MECKLENBURG COUNTY
DEPARTMENT OF ENVIRONMENTAL HEALTH

APPLICATION FOR SOIL INVESTIGATION

SITE EVALUATION

RE: Property located at Claiborne Dr. & Balmoral Dr.

**See Diagram on Back (includes: soil areas, property lines, roads, streams, gullies, wet areas, fill areas, wells, water bodies, slopes)

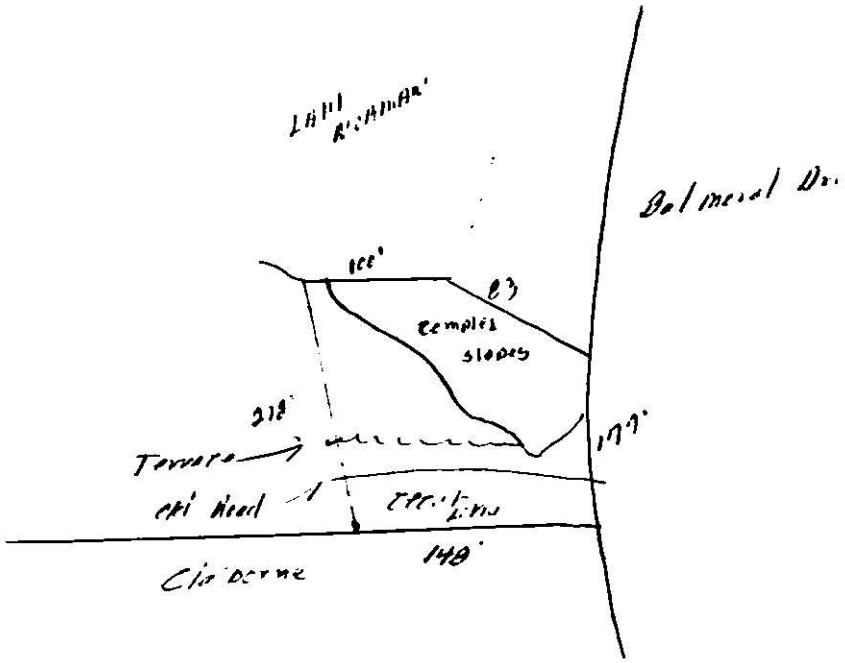
Recommendations/Comments: Consistent limited area - recommend plans for house system & well locations be submitted

At your request, a field investigation was conducted on the property designated above. The soils on the property were found to contain a limited area of provisionally suitable soil for the installation of a ground absorption sewage disposal system. A copy of the site evaluation report is enclosed for your information.

Should you desire to file for permission to install a ground absorption sewage disposal system, please submit plot plans for the proposed construction, well, and ground absorption sewage disposal system to this office. They will be reviewed and if it is found that there is an adequate area of provisionally suitable soil to accommodate the proposed installation, an Improvements Permit will be issued by this office.
